SERVICE BULLETIN NO. 170

SUBJECT: AIR FILTER RETENTION SCREEN

SERIALS AFFECTED: AA5-0641 and Subsequent and all
AA5A Aircraft.

FOR -501 AIR BOX ASSY
 FIGURE 1 OF SERVICE BULLETIN NO.170

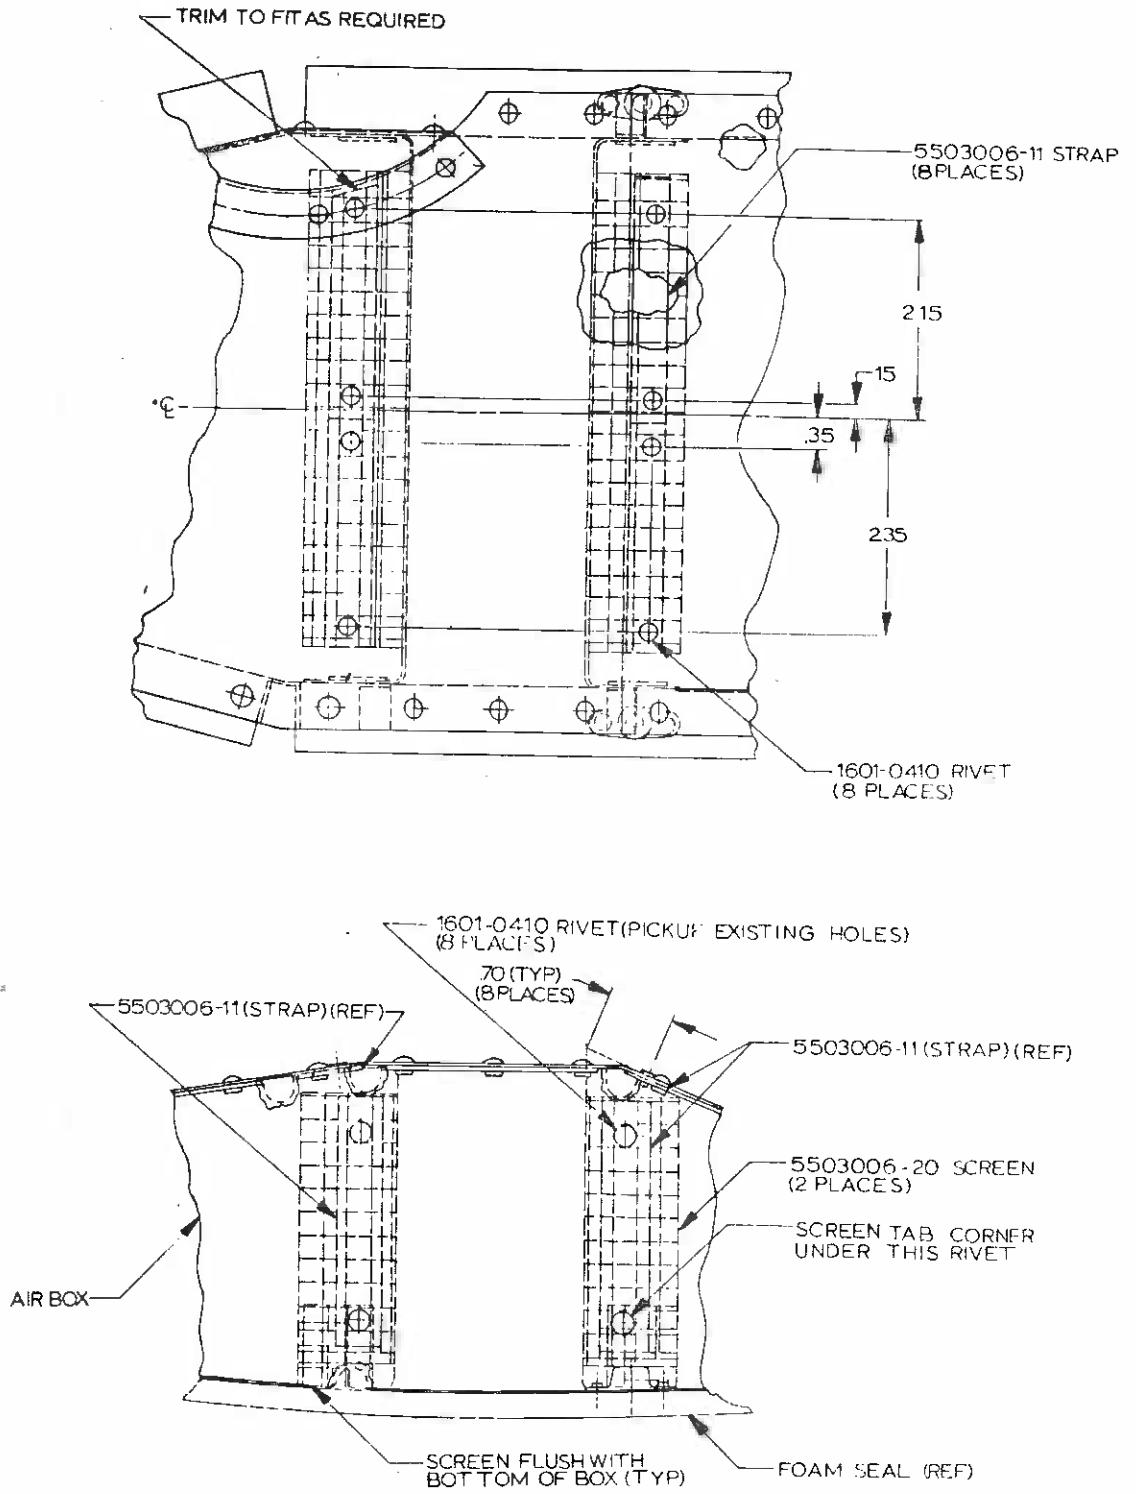
Some AA5 and AA5A aircraft have had breakage of the P/N 5503006-9 air filter retention screen. This can result in the ingestion of the air filter into the carburetor throat and possible loss of engine power. The purpose of this bulletin is to cover inspection and replacement of the P/N 5503006-9 air filter retention screen.

1. Inspect both forward and aft P/N 5503006-9 air filter retention screens in the area of the bends to see if any of the wires are broken.
2. If there is no visible breakage, inspect every 100 hours thereafter.
3. If breakage is found and that breakage is less than five wires per screen, inspect for foreign object damage (FOD) in the area of the carburetor. Continued operation is permitted until the improved screens can be installed, however, the broken screens must be inspected every 5 hours to check for further damage.
4. If more than five wires are broken on either screen, the screen should be replaced before further flight.

1. Remove rivets in both old screens straps. Remove and discard screens and retaining straps.
2. Clean air box thoroughly in area around screens.
3. Check to see that new screens (P/N 5503006-20) fit in box snugly with overlapped corners toward open side (bottom) of box. Take care that bend radius is not allowed to be smaller than 1/8 inch.
4. Install new 5503006-11 side retainer straps, forming wire slightly if required, to allow rivets to go through wire openings. Make sure that overlapped corners are riveted under the retaining straps.
5. Install top retainer straps as shown on Figure 1. Holes should be centered in screen openings.
6. Seal rivets with Pro Seal 700 to prevent leakage.
7. Install old filters if serviceable or new filters as required.
8. Reinstall air box.
9. Enter compliance with Service Bulletin No. 170 in aircraft log, and return to service.

<u>QUANTITY</u>	<u>PART NUMBER</u>	<u>NAME</u>
2 ea.	5503006-20	Screen
8 ea.	5503006-11	Retainer Strap
16 ea.	1601-0410	Rivets
